Item # 5
MCPB 12-04-03

THE MARYLAND-NATIONAL CAPITAL PARK AND PLANNING COMMISSION

MEMORANDUM

REVIEW TYPE: Site Plan
APPLYING FOR: 9,900 square feet industrial use
PROJECT NAME: Scandinavian Import Service Center
CASE #: 8-00024B
REVIEW BASIS: Site Plan Review required for Auto Sales in this zone [59-C-5.21]

PROJECT DESCRIPTION: Proposal

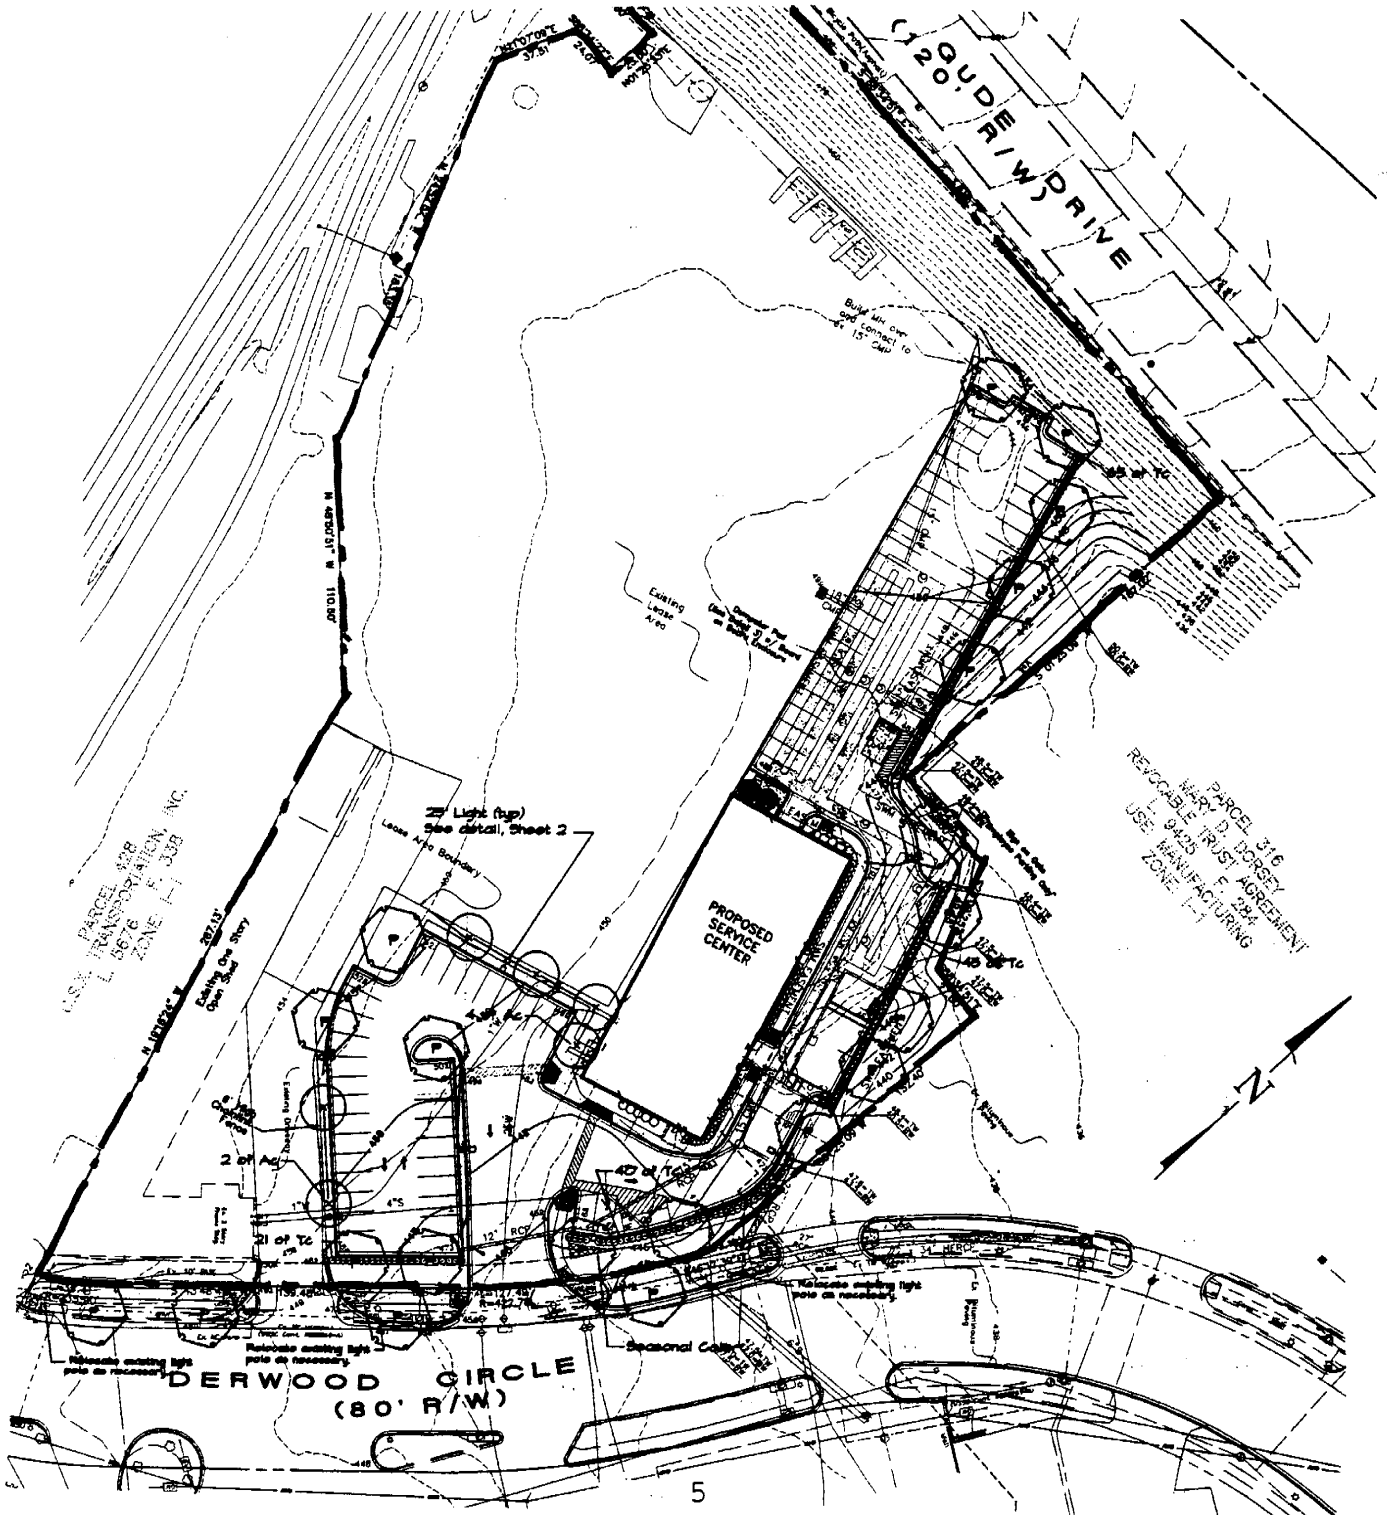
The proposed development consists of a two-story, 9,900-square-foot automobile service and sales building on the undeveloped eastern portion of the site. The facility will provide indoor/outdoor auto repair and sales display. Parking will be provided for service customers, purchasers, automobile storage, and employee vehicles. Vehicular access to the new development will be via a driveway off Derwood Circle. There are three existing curb cuts along the Derwood Circle frontage. Two of them will be combined into one access point to accommodate the proposed driveway leading to the new development area. The stormwater management for the development will be provided via an underground facility for water quality and quantity controls.
